## IMPORTANT PRODUCT UPDATE

Date: 03/09/20  
To: DIS185SSI4F Air Compressor Owners  
From: Multiquip Product Department  
Subject: Controller Adjustment — **ACTION REQUIRED**

# Service Bulletin

## DIS185SSI4F Controller Adjustment

**Figure 8. Controller Display (P-60)**

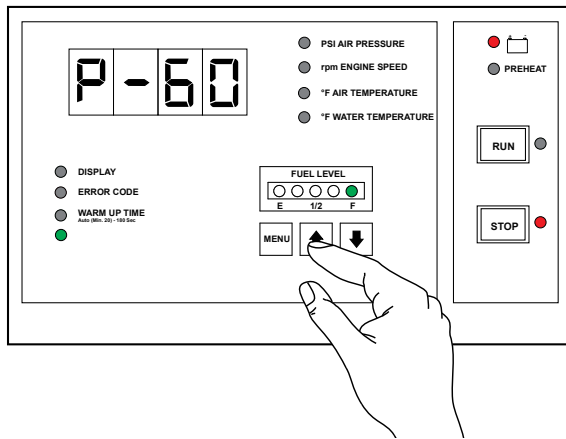
- Push the arrow button to change the display to "P-60" as shown in Figure 8. Push the MENU button.

**Figure 9. Controller Display (5000)**

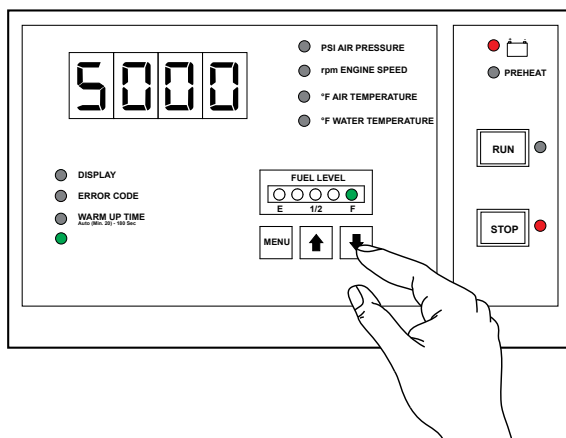
- When MENU button is pushed, the display will change to "5000", indicating the low speed shutdown time of 50 seconds as set in the factory. See Figure 9.

**Figure 10. Controller Display (500)**

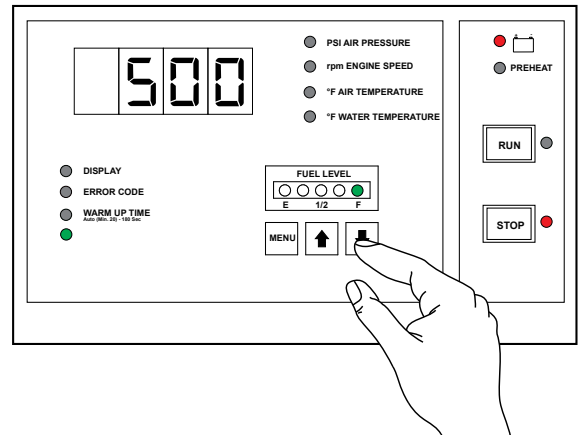
- Push the arrow button until the display changes to "500" to reset the low speed shutdown time to 5 seconds as shown in Figure 10. Push the MENU button to save the new setting.
